REFERENCE:	TSB: 19-004-23 REV. A GROUP 19 - Steering	Date:	May 23, 2023	REVISION:	19-004-23
VEHICLES AFFECTED:	2021 - 2023 (WL) Jeep Grand Cherokee This bulletin applies to vehicles built on or after December 03, 2020 (MDH 1203XX) **and on or before April 27, 2023 (MDH 0427XX)** .	MARKET APPLICABILITY:			
		<input checked="" type="checkbox"/> NA		<input type="checkbox"/> MEA	
		<input type="checkbox"/> SA		<input type="checkbox"/> IAP	
		<input type="checkbox"/> EE		<input type="checkbox"/> CH	
CUSTOMER SYMPTOM:	<p>The customer may experience one or more of the following:</p> <ul style="list-style-type: none"> • A popping noise can be heard when turning, while in the driver seat. • One or both of the tie rod boots are extended, or compressed (Fig. 1) . 				
CAUSE:	Pressure differential inside the tie rod boot.

This bulletin supersedes Technical Service Bulletin (TSB) 19-004-23, date of issue March 30, 2023, which should be removed from your files. All revisions are highlighted with ****asterisks**** and include an updated build date and RSU number.

Fig. 2
Tie Rod Assembly

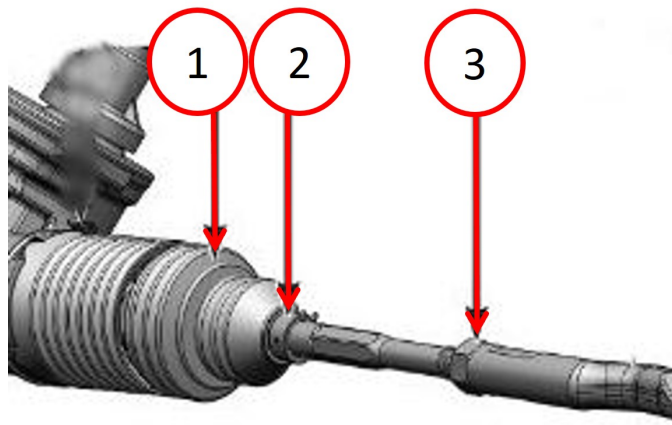
2. Remove the small tie rod boot clamp from the inner tie rod (Fig. 2) .

3. Pull the tie rod boot outwards towards the jam nut (Fig. 2) , so the end of the boot passes the hex portion of the tie rod. **This will break the seal and allow the tie rod boots to breath and equalize. A hiss of air escaping may be heard.**
4. Install the tie rod boot back into the groove on the inner tie rod (Fig. 2) . Verify the boot is in the groove.
5. Install the small tie rod boot clamp on the tie rod (Fig. 2) .
6. Lower the vehicle.
